F096
SERVICE BULLETIN

POTENTIAL FOR THE BATTERY CABLE INSULATION FAILURE ON PROCUT S SERIES MODELS

MODELS AFFECTED			
Brands	Model Nos.:	Serial No. Range:	Description:
Ferris	5900631, 5900651, 5900652, 5900701	2012588981 & Below	ProCut S Series Three Wheeled Riding Mowers

**Figure 1. Inspect for Vinyl Hose Clamp
A. Vinyl Hose Clamp**

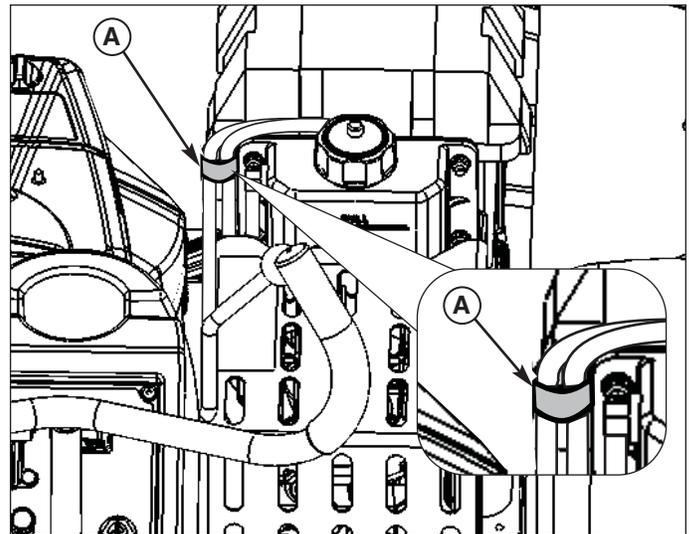
Field reports indicate that models listed above serial range could potentially have issues with the battery cable insulation failing.

1. Refer to Figure 1. If your machine is equipped with vinyl hose clamp (A), no further action is require. If not equipped with the hose clamp or if equipped with wire tie continue to corrective procedures.

1. Order and install kit number 5600168.
